Addendum No.: 2

York Correctional Institution Central Plant and Piping Distribution

BI – JA – 465

The following clarifications are applicable to drawings and specifications for the project referenced above.

D 7 BREECHING ROOF PENETRATION
NTS

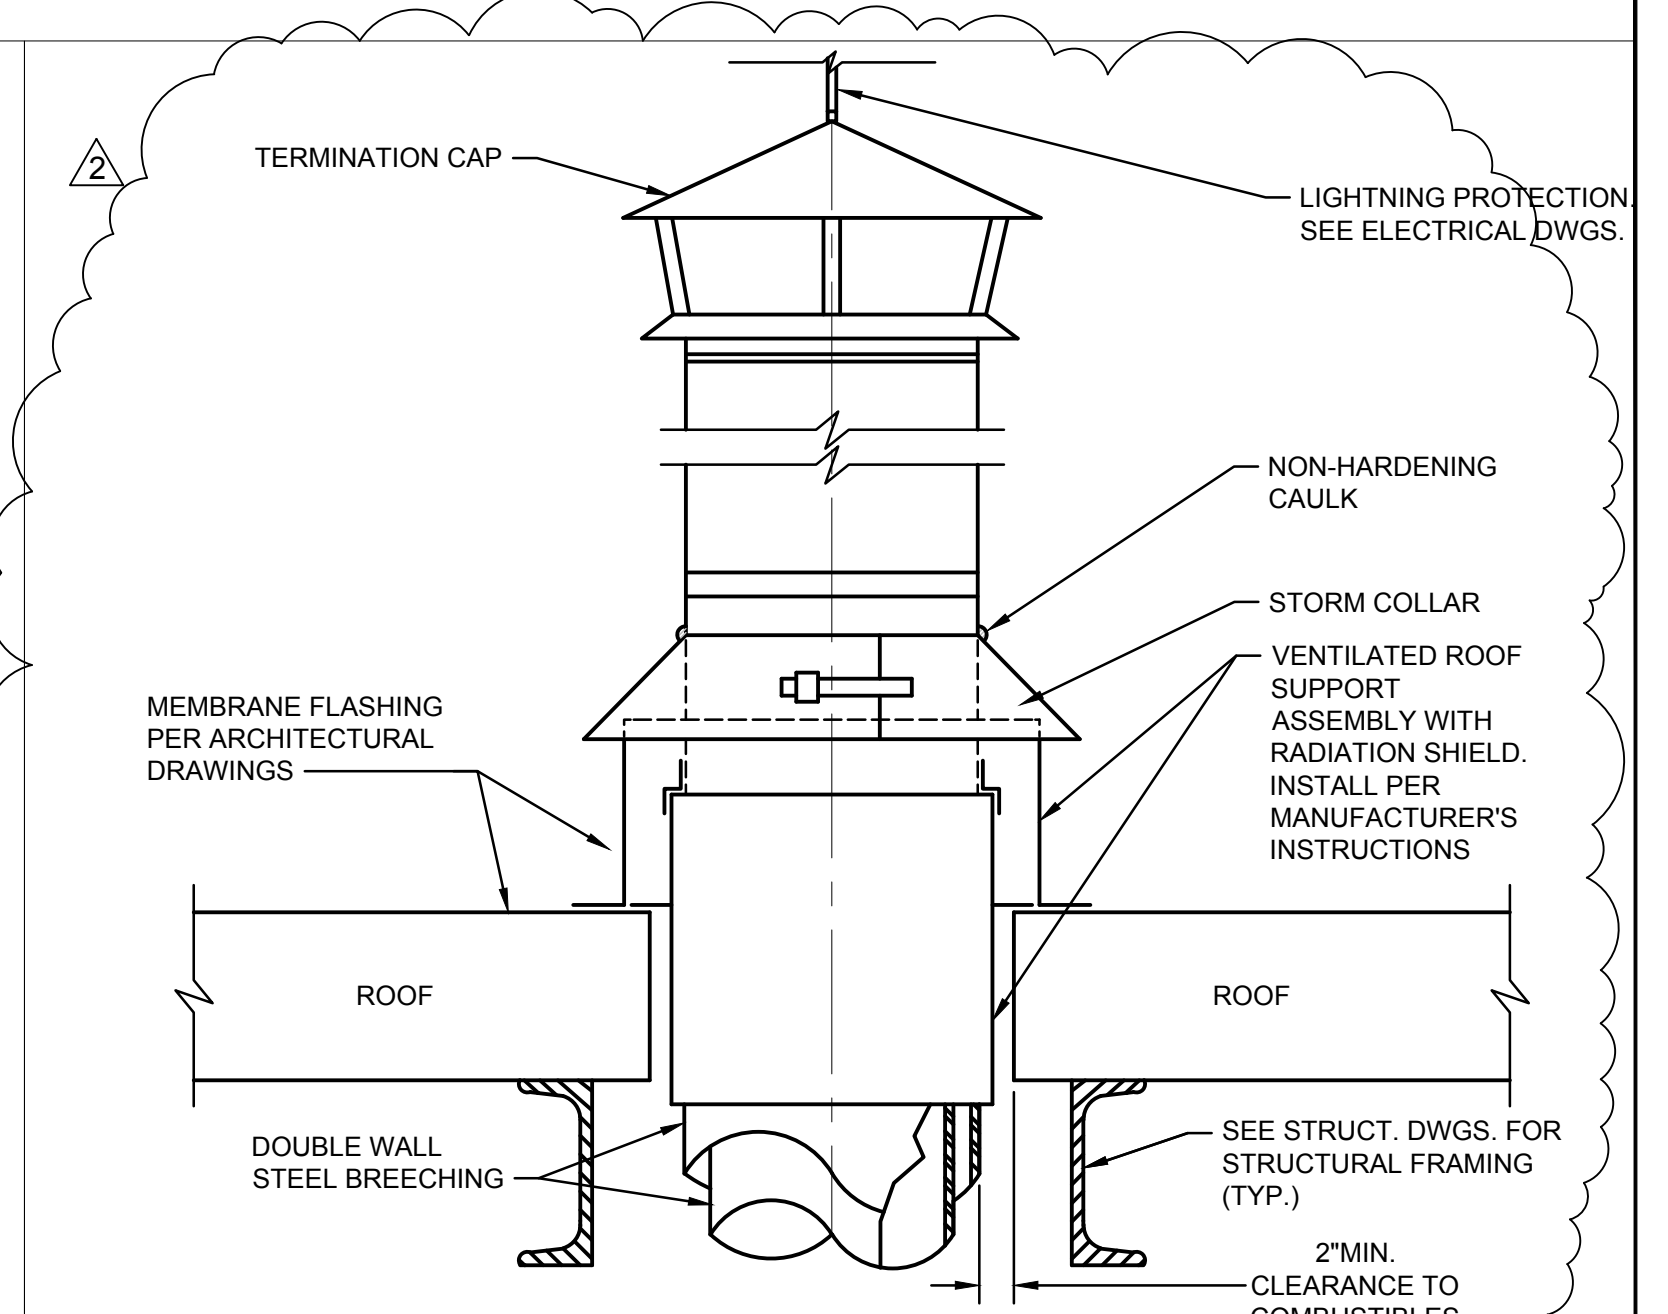
Drawing M906 Details - 7

REPLACE the entire drawing with the attached.

ADDED boiler stack roof penetration detail

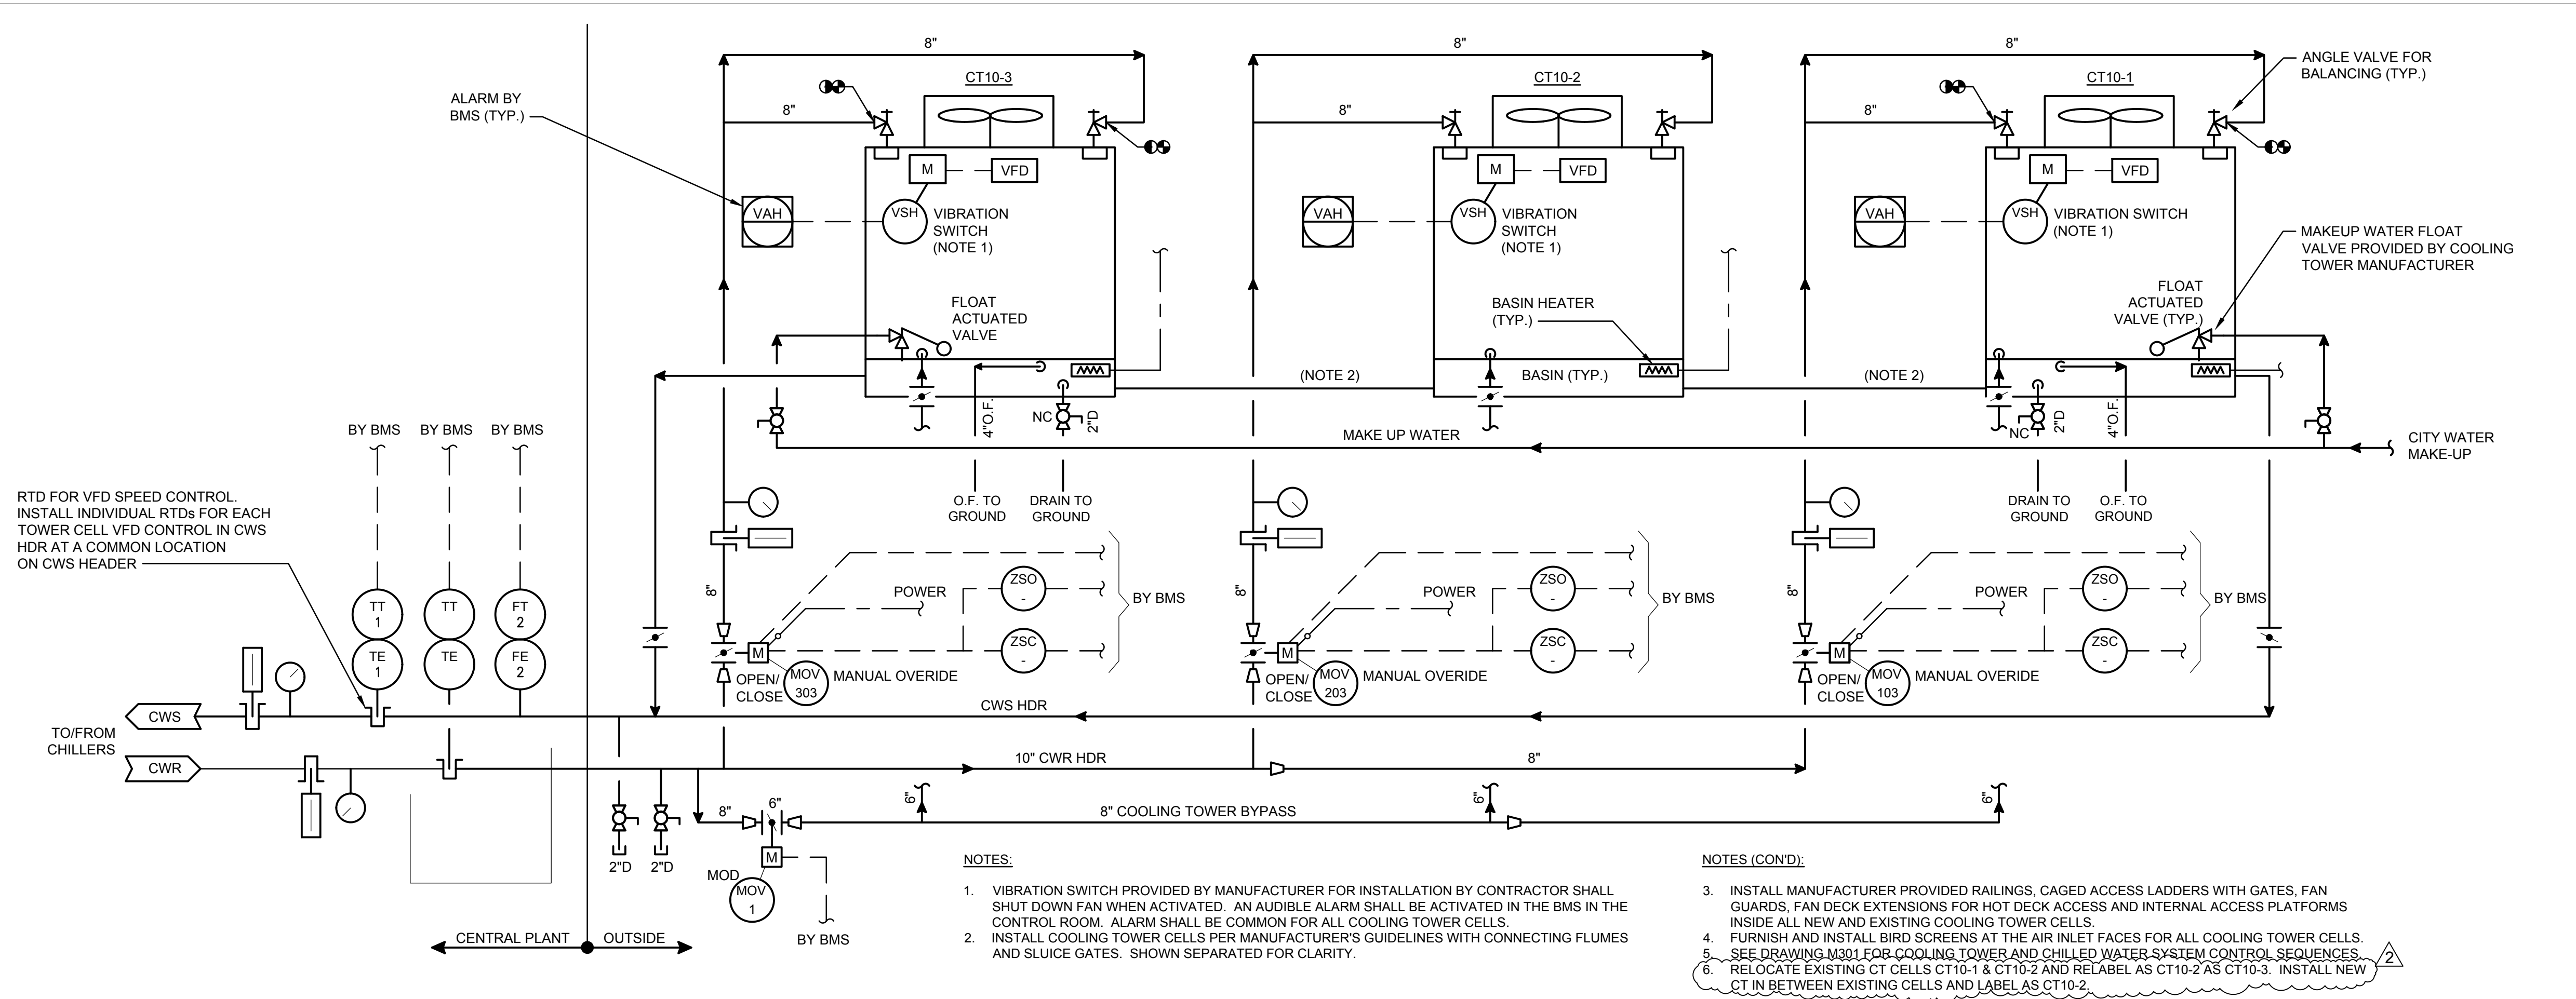
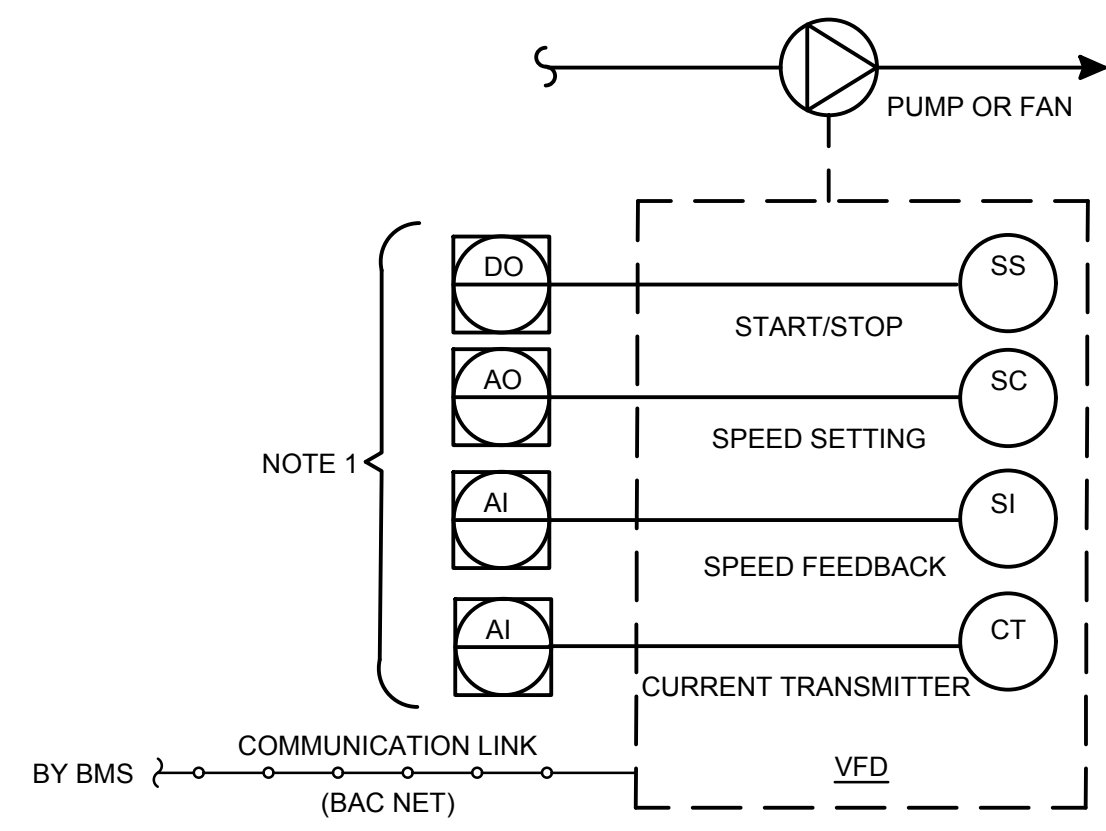
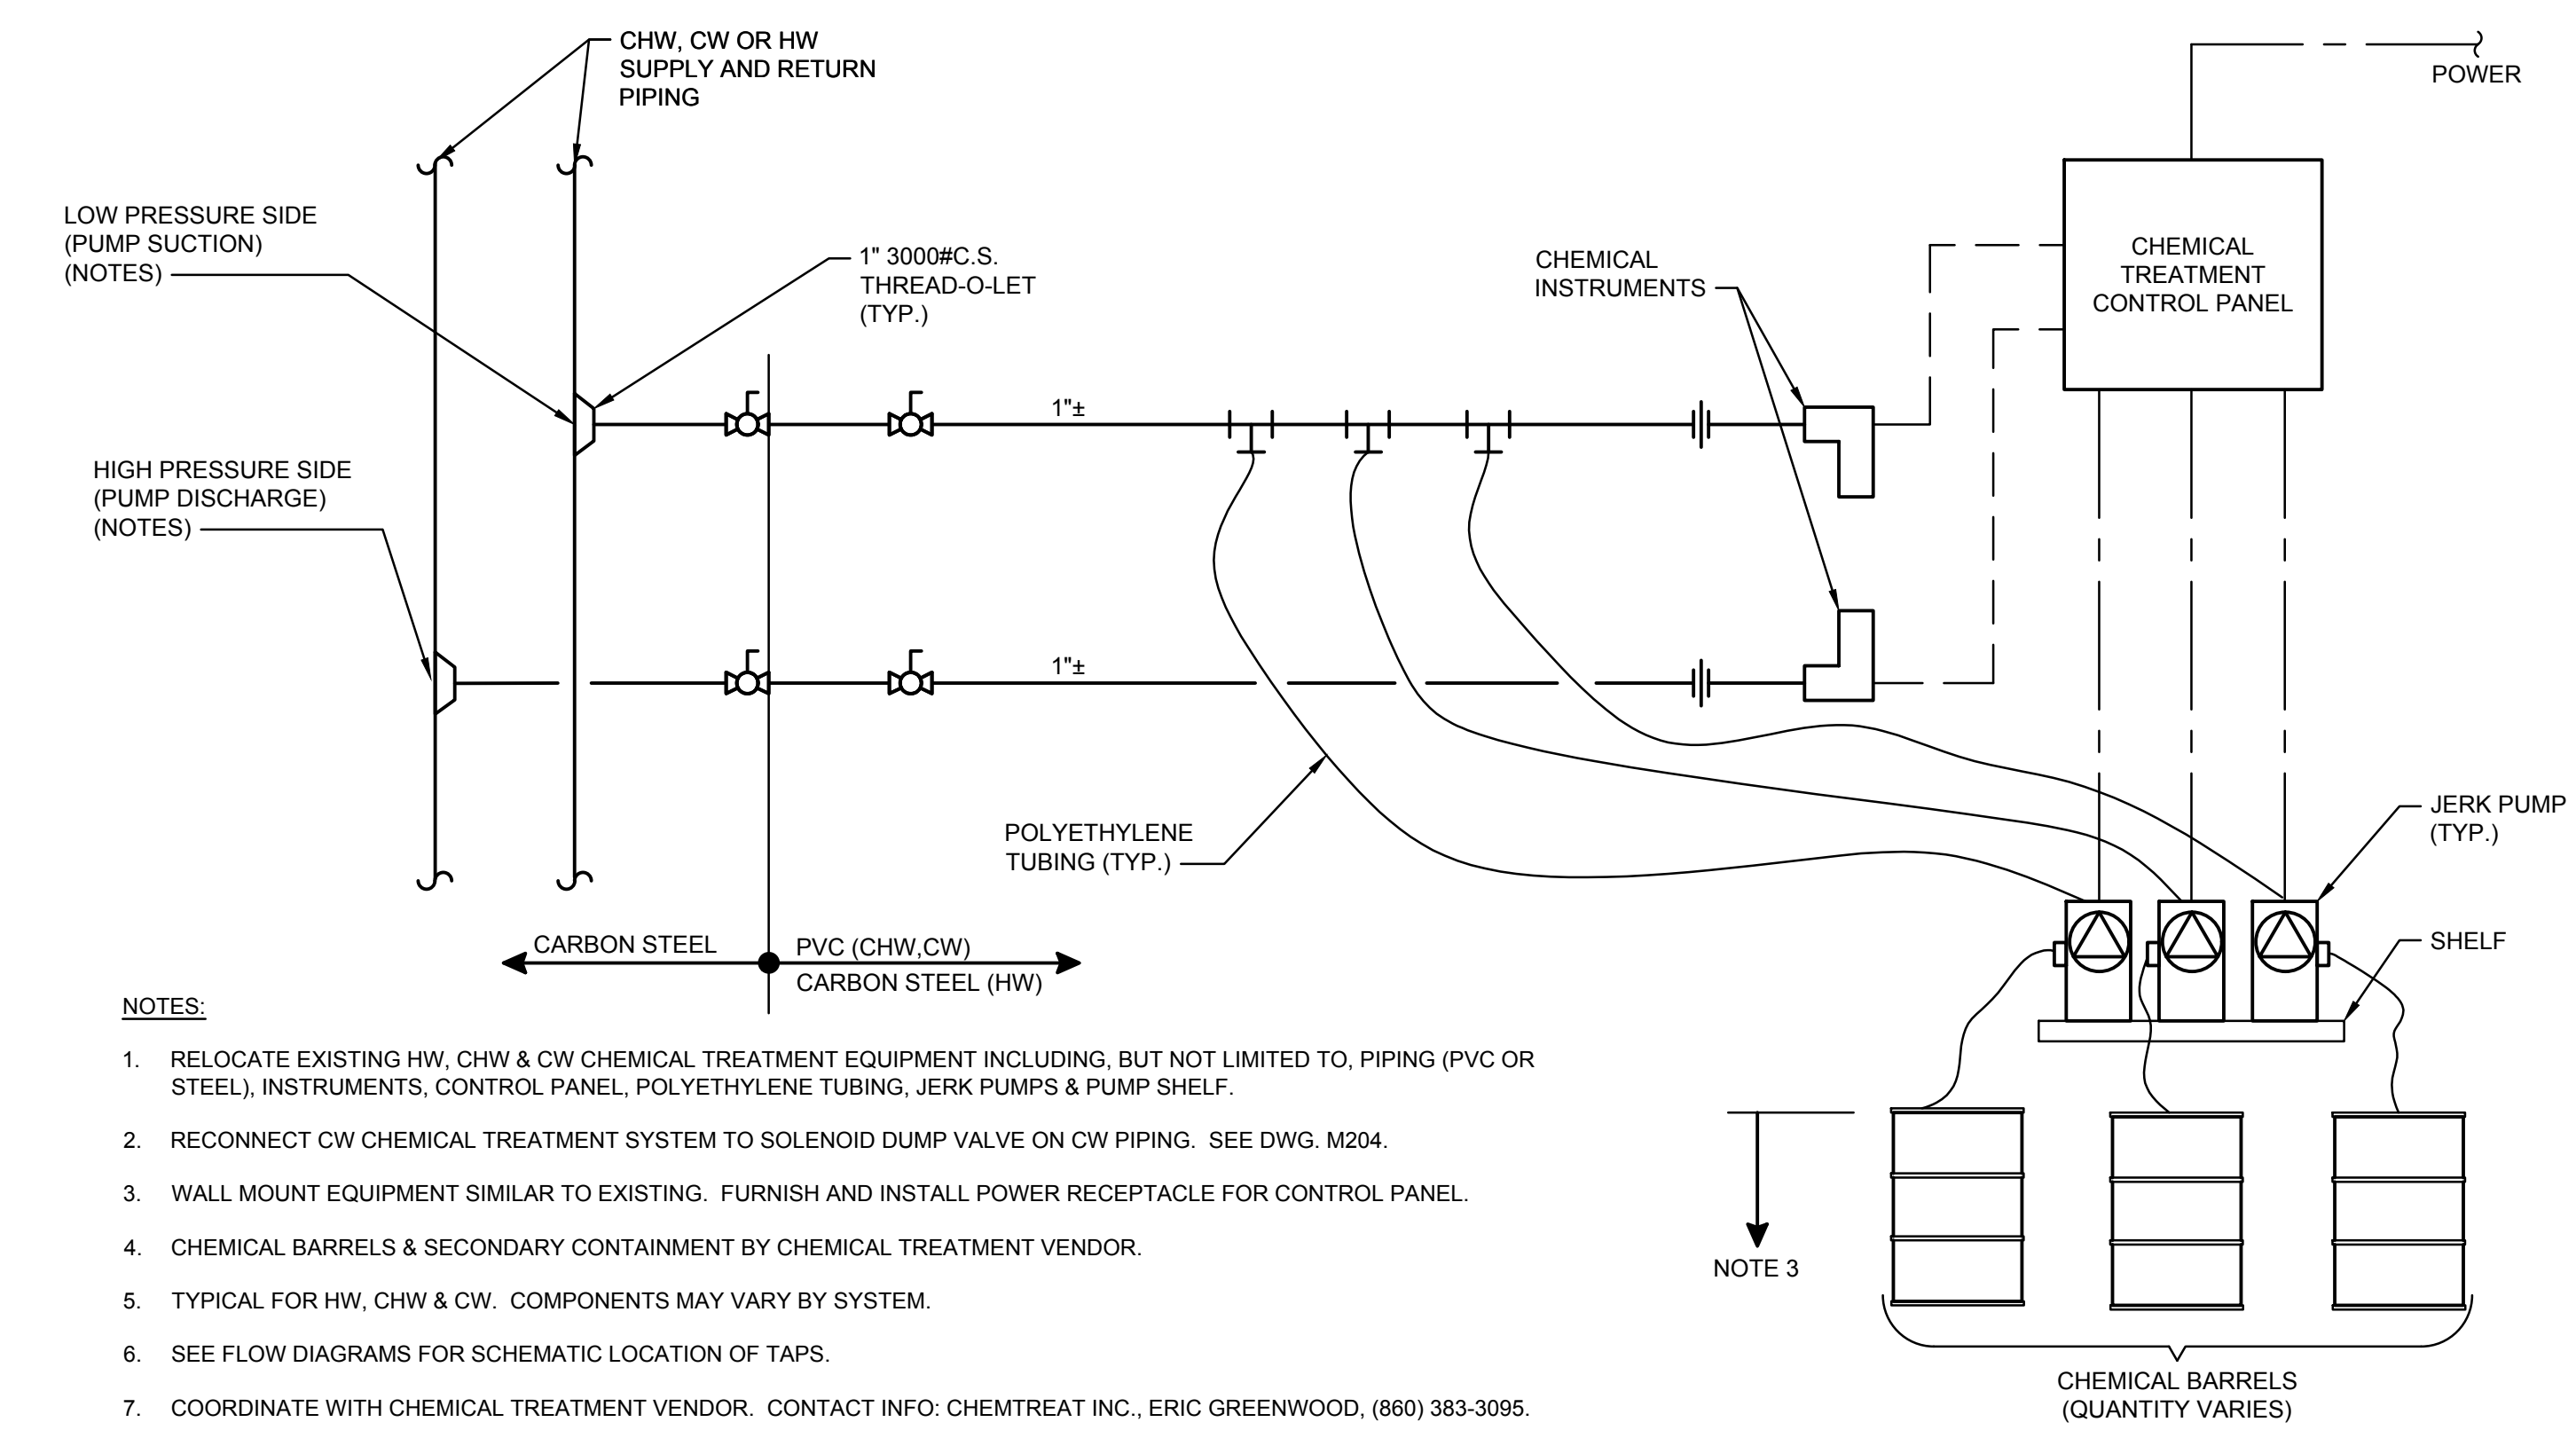
Drawing M907 Details - 8

REPLACE the entire drawing with the attached.
